Volvo Car USA LLC
Technical Journal

Technical Journal Title Roller blind, rattle noise when opening		Ref. No. TJ 33183.9.1	
Issuer (Dept.) Technical Service		Issue Date 3/3/26	Status Date 3/3/26
Car Market United States and Canada	Partner 3 US 7510 Volvo Car USA	Function Group 8364	
Function Description Sun visor, roof hatch		Page Page 1 of 15

TJ Instruction VCC-519080-1

TJ Instruction VCC-519080-3

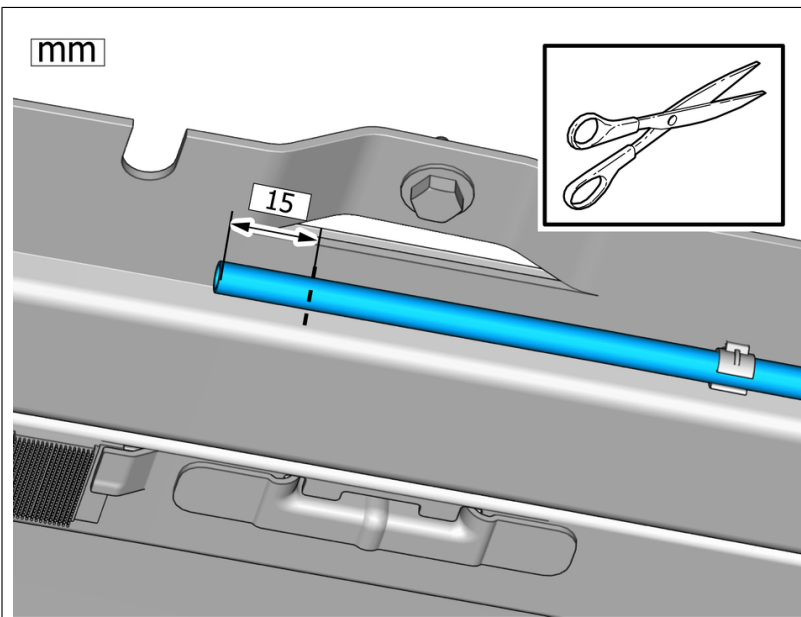
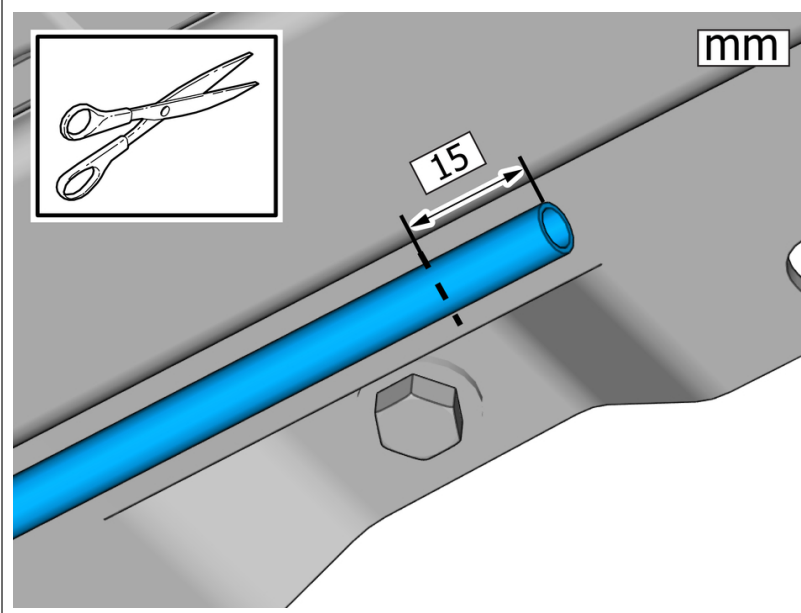
Right-hand side
Cut the component according to the image.

Left-hand side
Cut the component according to the image.
